# **North Liberty Planning Commission**

NORTH LIBERTY PLANNING COMMISSION  
MEETING NOTICE AND AGENDA  
**Tuesday, June 5, 2018, 6:30 PM**  
**North Liberty City Council Chambers, 1 Quail Creek Circle**

Subject: Request from Jeff Mekota to approve a site plan for a commercial warehouse development in the I-380 Industrial Park Area west of I-380.

# SITE PLAN I-380 INDUSTRIAL PARK, LOT 11 NORTH LIBERTY, IOWA

COVER SHEET

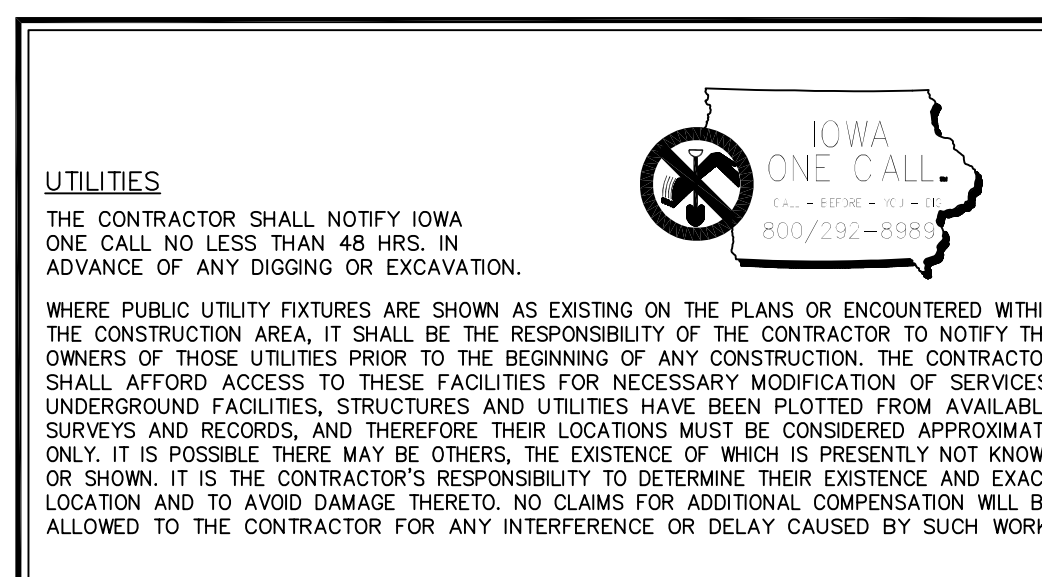
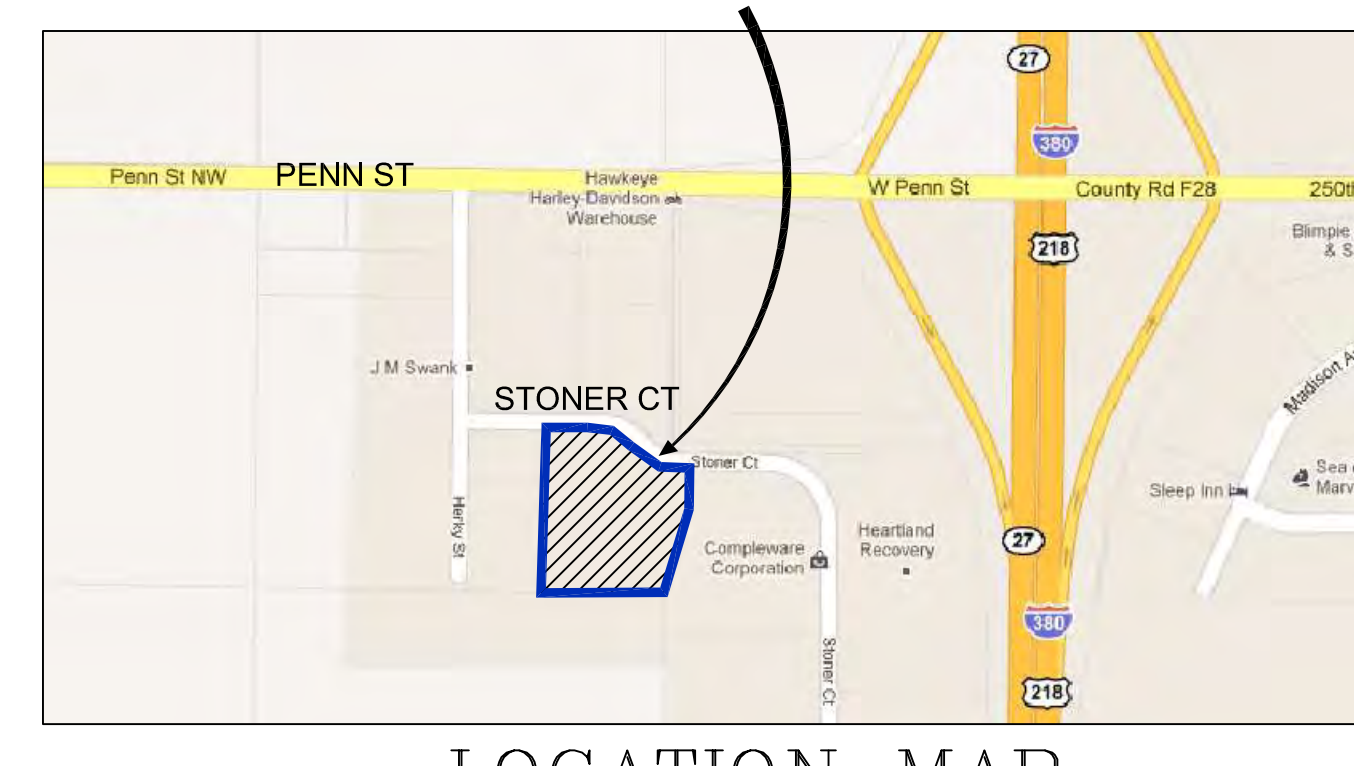
The site layout packs a lot of storage units on the site with reasonable setbacks and two very large buildings with 22 and 16 450 square foot units, though some units may be combined. Units are intended to be sold as condominium units, though that does not impact the site plan. The site is quite flat and stormwater drainage will be managed through a large stormwater basin at the south end of the lot. Landscaping meets minimum requirements but also includes additional trees along Stoner Court.

Parking for sites such as this is an ongoing problem for the City, and this plan has been modified from the initial submittal to provide substantially more on-site parking. The City standard for warehousing is 1 space per 2,000 square feet plus one space per employee. In most cases including this one, no one knows before the facility is built who the tenants or owners will be, so the space per employee

standard is hard to estimate; however, we do know from experience that minimizing the parking has proven to be woefully inadequate, and this developer has taken that into account by providing 66% more parking than the absolute minimum requirement.

Staff recommends approval of the site plan.

# South Ends of Buildings - away from Stoner Court

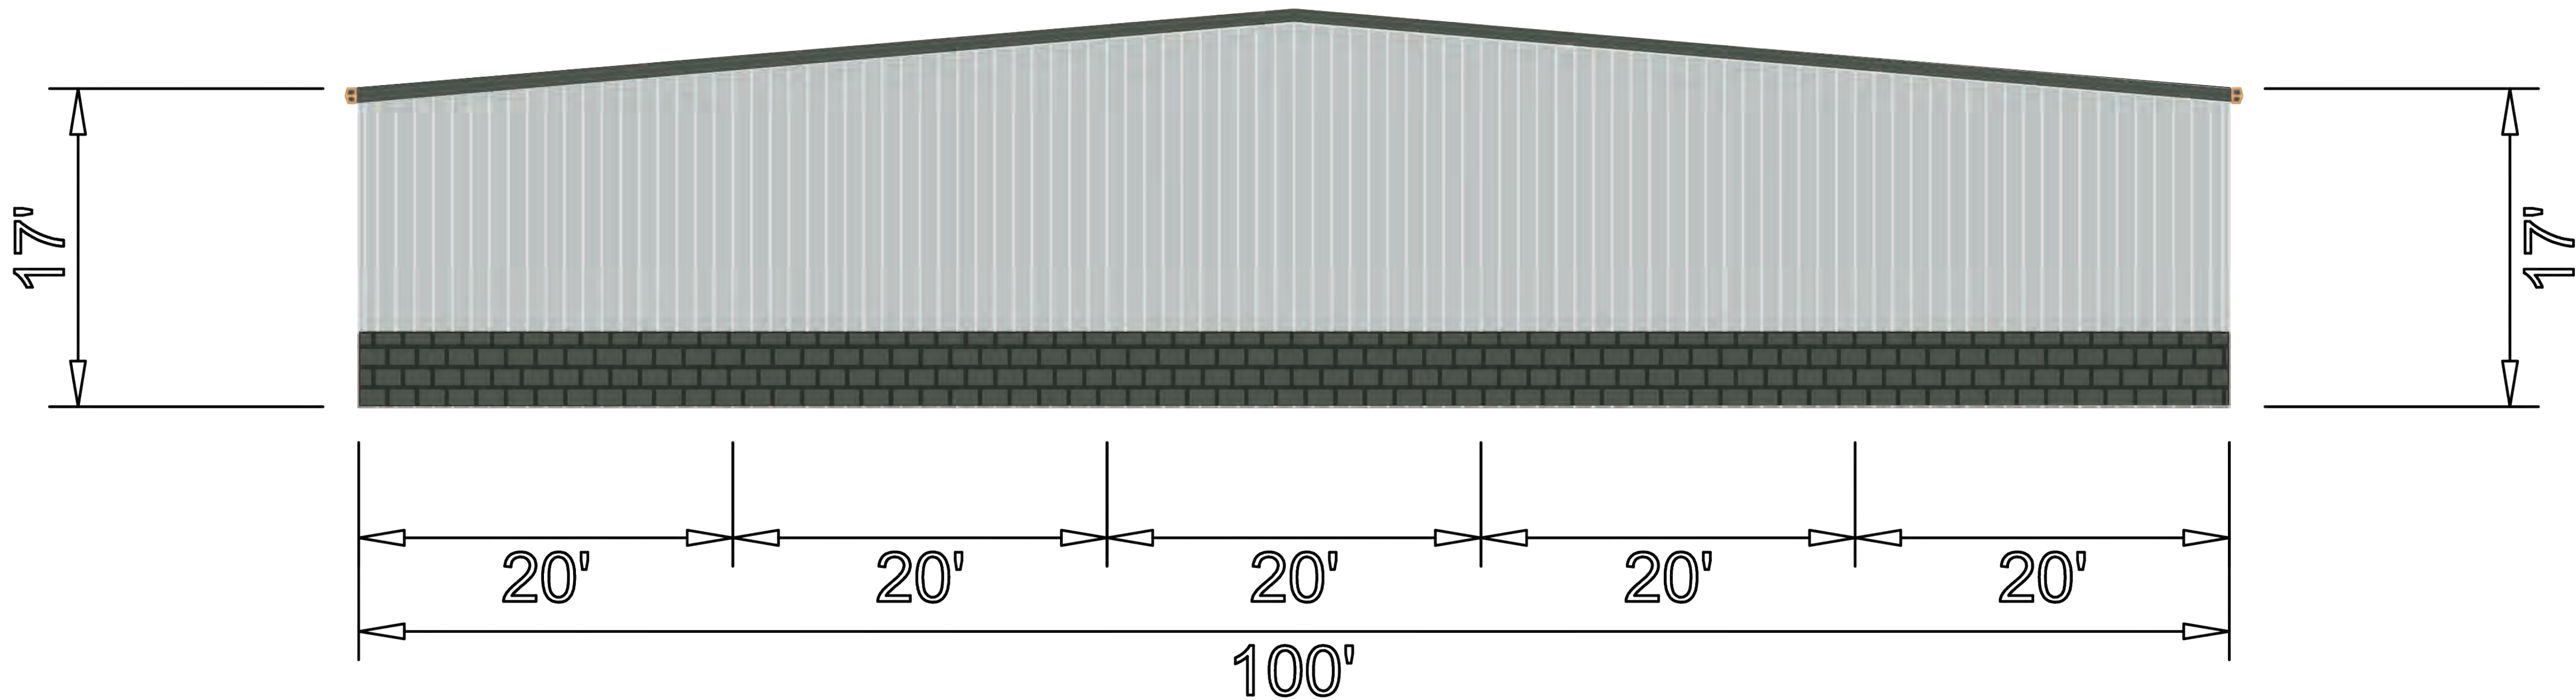
The buildings are metal construction, with masonry content that exceeds North Liberty standards for all building elevations. The most recent similar plans for mini warehouse development included windows within the outside elevations, which helped break up the monotony of the long sides, and featured enhanced building elevations through offsets and corner taller structures, but the difference between that site and this is that the former was in a commercially-zoned area highly visible from I-380 and this site is at an industrial-zoned lot internal to the area. In response to that staff recommendation in the preliminary report, the developer has proposed to add windows on the north sides of the buildings (facing Stoner Court), cutting into the masonry area in a visually interesting way.

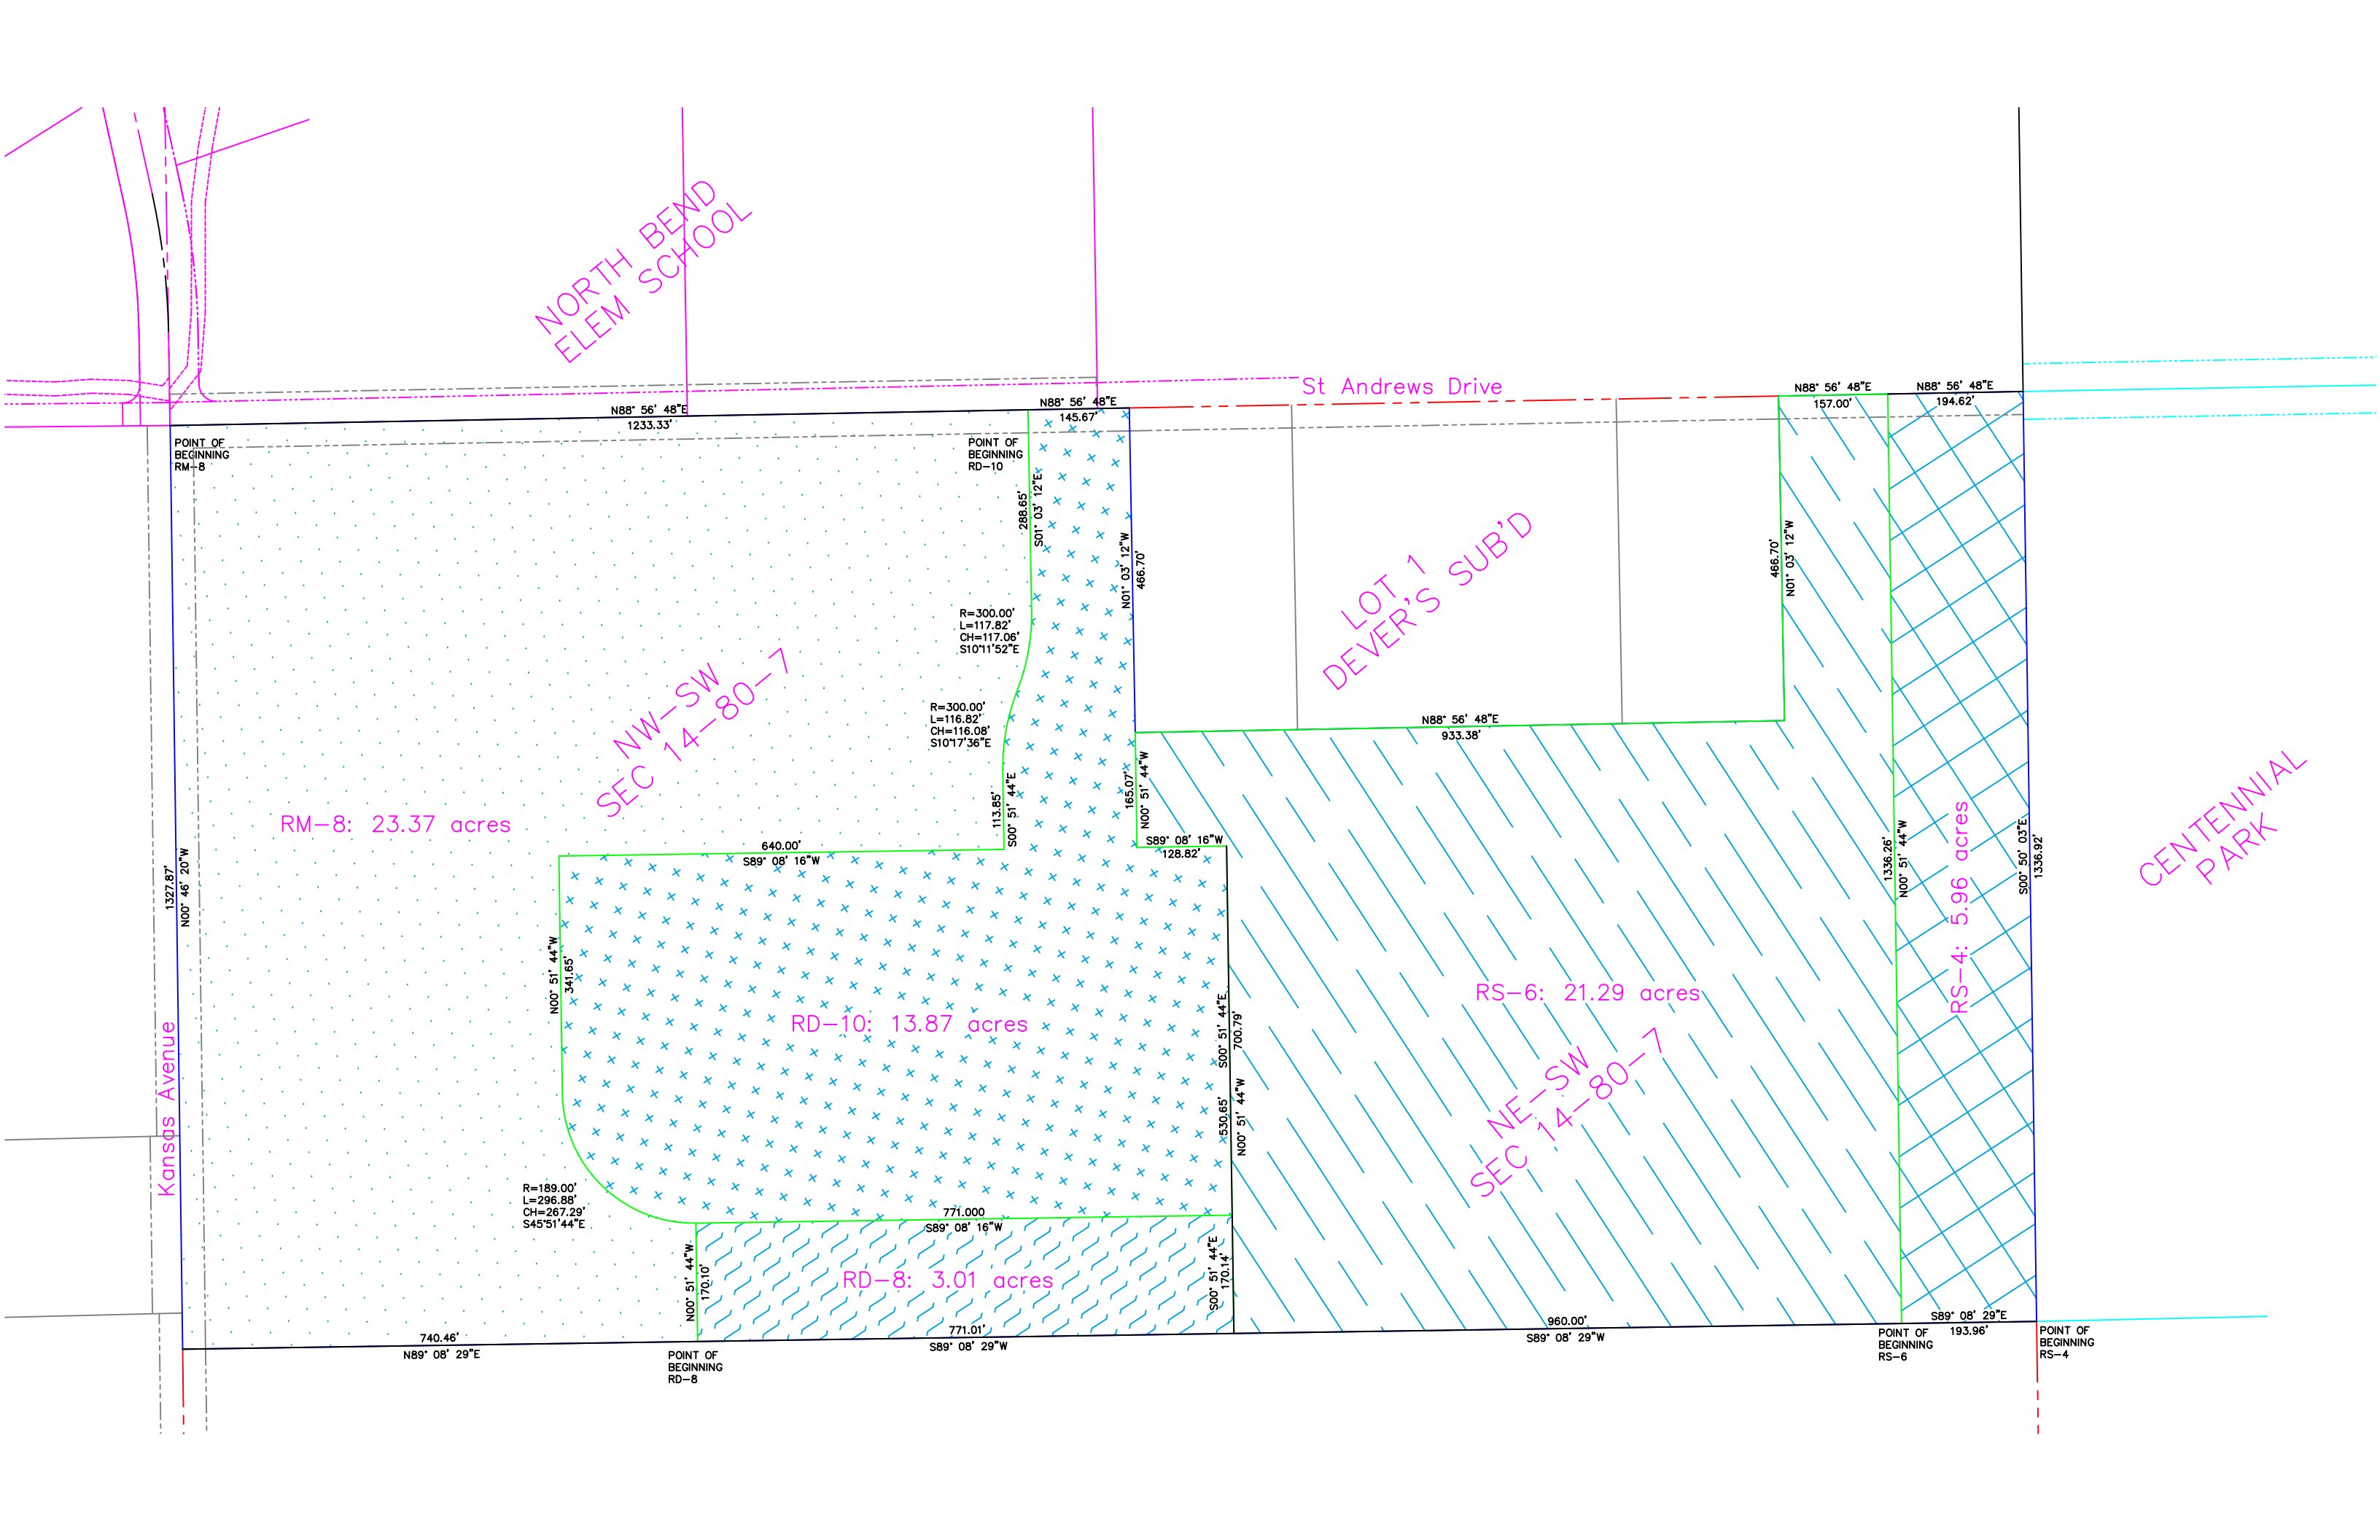
After careful consideration of the application, the location, and the potential precedents, staff recommended an increase in the single-family lots by one block, and a decrease in multi-family zoning as shown in the exhibit below, to be instead designated for duplex lots. While this recommendation does not make a large difference in the overall numbers, it does set up a somewhat more conservative density transition while acknowledging the positive aspects of the plan. It would result in a net increase of about 12 single-family lots and a net loss of about 10 duplex units. Multi-family impacts are harder to estimate, but the decreased size would likely have a net negative impact. It would result in the following summary:

After preparation of this report and discussions, the developer has proposed a compromise shown in the following table and exhibit, and staff recommends its approval.
